STATE OF CALIFORNIA  
CALIFORNIA NATURAL RESOURCES AGENCY  
DEPARTMENT OF WATER RESOURCES  
DIVISION OF SAFETY OF DAMS

**INSPECTION OF DAM AND RESERVOIR IN CERTIFIED STATUS**

Name of Dam Soulajule Dam No. 33-9 County Marin  
 Type of Dam ERTH Type of Spillway Concrete weir and chute  
 Water is 6 feet below the spillway crest and 18 feet below the dam crest.  
 Weather Conditions Clear and mild  
 Contacts Made Lucy Croy, Conner Pollard, and Carl Sanders during the inspection  
 Reason for Inspection Periodic Evaluation

Inspected by J. Lowe  
 Date of Inspection 13 February 2018  
 Date of Report 16 February 2018

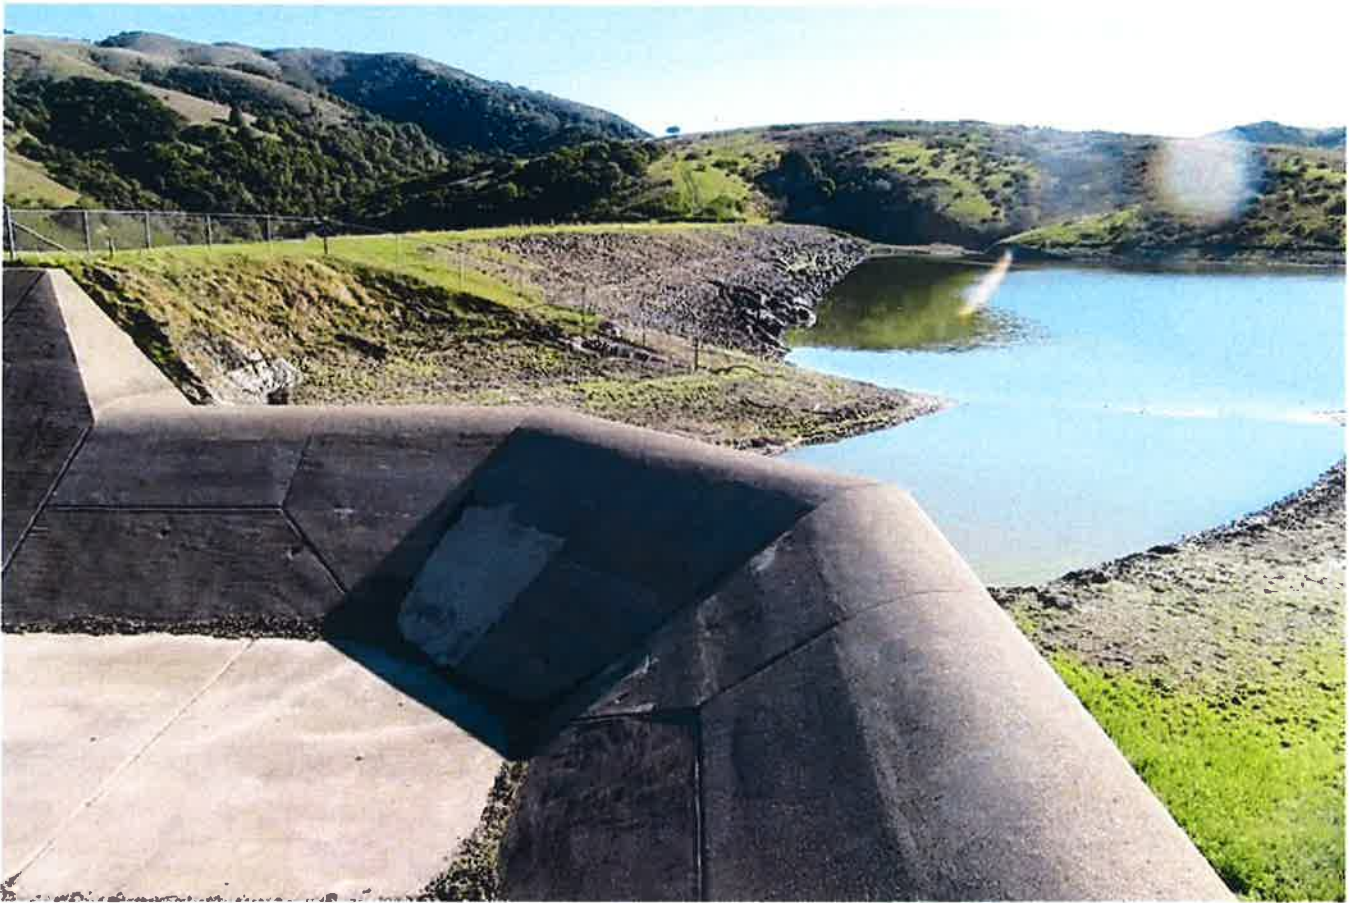
Primary access to the dam when the spillway is flowing has been improved by placing course gravel armor on the alternate access road located along the right side of the dam. Access is now satisfactory.
